ENGINE - HIGH PRESSURE TURBINE STATOR - (72-53-00) - LEAP-1A HPT CASE REMOVAL

SERVICE BULLETIN

Task type:
 Modification

Original issue date:
 2020-10-22

Port Serial Number Locations Figure 1 (Sheet 1 of 2)

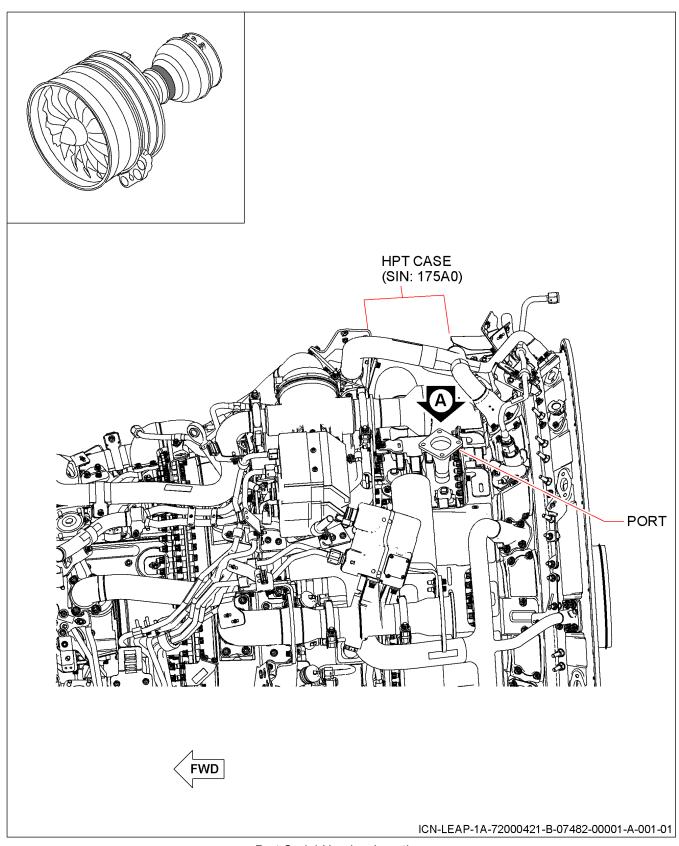
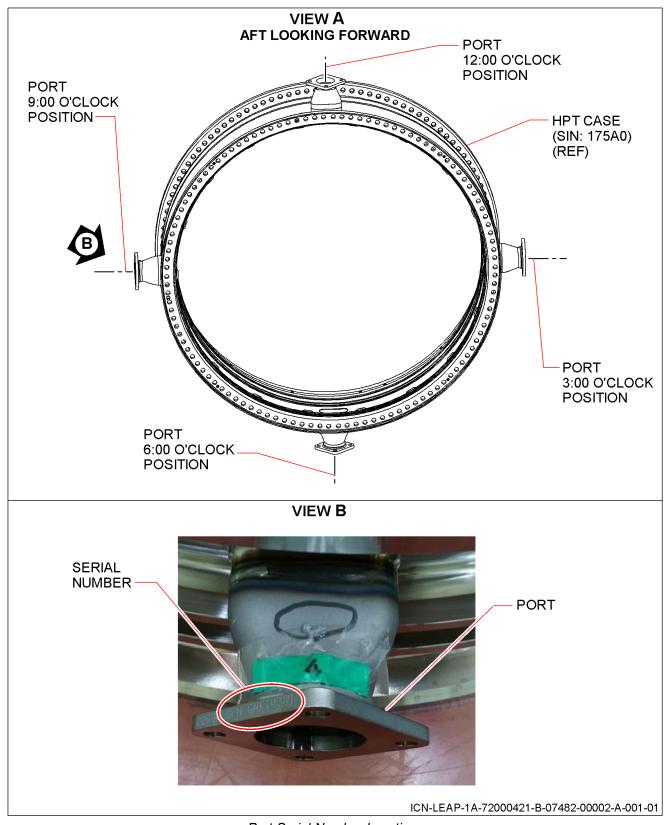
- (1) Do an inspection of the four port casting serial numbers of the HPT case (SIN: 175A0, Figure 1) listed in the LEAP-1A S/B 72-0417 (Refer to SB: LEAP-1A-72-00-0417-01A-930A-D) and do as follows:
 - (a) If any of the four port casting serial numbers match the port casting serial numbers listed in Table 1, do the steps in paragraph 5.B. of this Service Bulletin.
 - (b) If none of the four port casting serial numbers match the port casting serial numbers listed in **Table 1**, no action is necessary. Refer to paragraph 6., ADDITIONAL INFORMATION for the CFM Aviation Fleet Support contact information.

- (1) Remove the affected HPT case (SIN: 175A0, Figure 1) from engine. Refer to the LEAP-1A ESM, 72-53-00, DISASSEMBLE PROCEDURE (Refer to: LEAP-1A-72-53-00-01A-530A-C).
- (2) Contact CFM Aviation Fleet Support to get shipping instructions to return the affected HPT case (SIN: 175A0, Figure 1). Refer to paragraph 6., ADDITIONAL INFORMATION for the CFM Aviation Fleet Support contact information.
- (3) Install a new or serviceable HPT case (SIN: 175A0). Refer to the LEAP-1A ESM, 72-53-00, ASSEMBLE PROCEDURE (Refer to: LEAP-1A-72-53-00-01A-710A-C).
- (4) Inform CFM through GE Aviation Fleet Support that the affected HPT case (SIN: 175A0, Figure 1) was removed. You must include the engine serial number (ESN), HPT case (SIN: 175A0) part number and
